SERVICE BULLETIN

Number: 15-001

GM 6.6L Cable Connection Mandatory Product Improvement

Fig 2

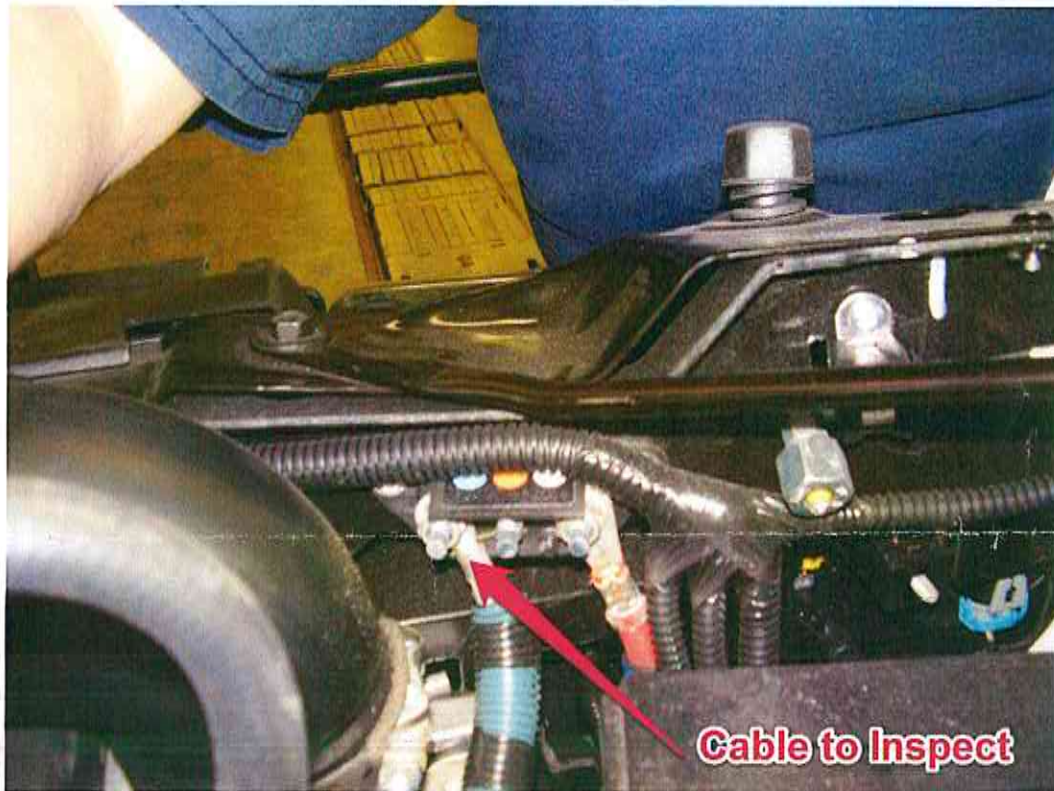
1. Open hood.
2. Locate the terminal strip (three studs) See Fig. 1 & Fig 2
3. Verify that the cable (blue) on the stud nearest the driver's side is secured correctly. See Fig. 3 & Fig 4

Inspect cable-to-stud connection. If the cable is angled (off vertical) over the edge of the terminal strip, loosen the self-locking nut and slightly rotate the cable to its proper vertical position, and tighten the nut securely.
